**ISSUE:** Permit to Demolish/Capsulate (partial) and Certificate of Appropriateness for alterations and addition

**LOCATION:** Old and Historic Alexandria District  
820 South Lee Street

**STAFF RECOMMENDATION**

Staff recommends approval of the Permit to Demolish/Capsulate (partial) and Certificate of Appropriateness for alterations and addition, with the following conditions:

Figure 1: Proposed primary/west elevation

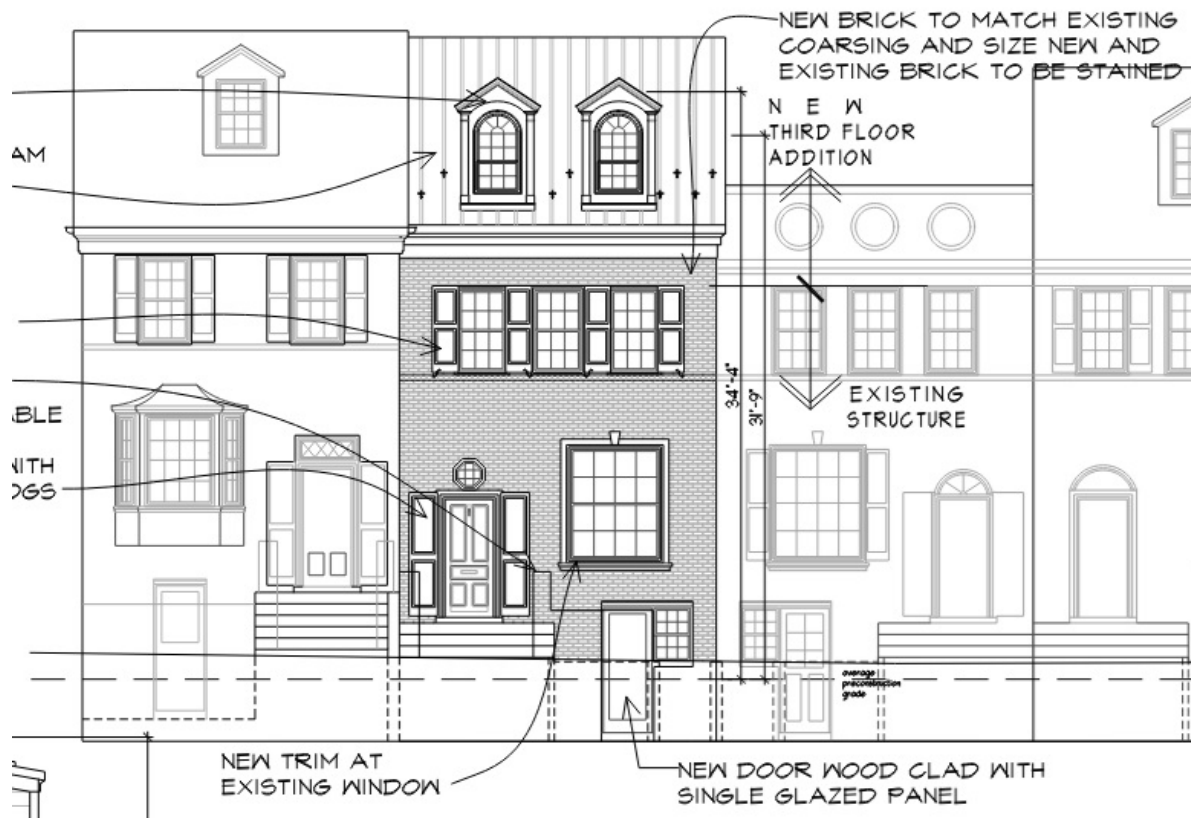
The *Design Guidelines* encourage “respectful additions” which “make use of the design vocabulary of the existing...structure” and supports additions that “are compatible with both the architectural character of the existing house and the immediate neighborhood.” Staff finds that the proposed Colonial Revival addition fully complies with these guidelines. Figure 1 depicts the west elevation of the proposed addition to 820 South Lee in the context of its blockface. The subject property will be no taller than 818 South Lee immediately to the north and will harmonize with 822 and 824 to the south. Much like other houses on the block, the proposed third story will have gable dormer windows. The new entry door to the basement will be wood clad with a single glazed window panel.

The standing seam metal roof will improve the appearance of the primary elevation, as will the new operable paneled shutters with shutter dogs. Staff also finds that staining the exterior brick would be appropriate for this 1950s building. It will not harm the brick and could improve the house's appearance, as the brick is currently an unusual color with some areas of discoloration. The new Pella Architect Series windows are appropriate and could be administratively approved. However, the application does not contain specifications for the glazing of these windows; those will need to be supplied prior to the issuance of the building permit.

With the conditions that the shutters be made of wood, the shutter dogs be installed in mortar joints, and the replacement window/door glazing is clear, reflective, without tint, complying with the *Alexandria New and Replacement Window Performance Specifications in the Historic Districts*, staff recommends approval of the project.
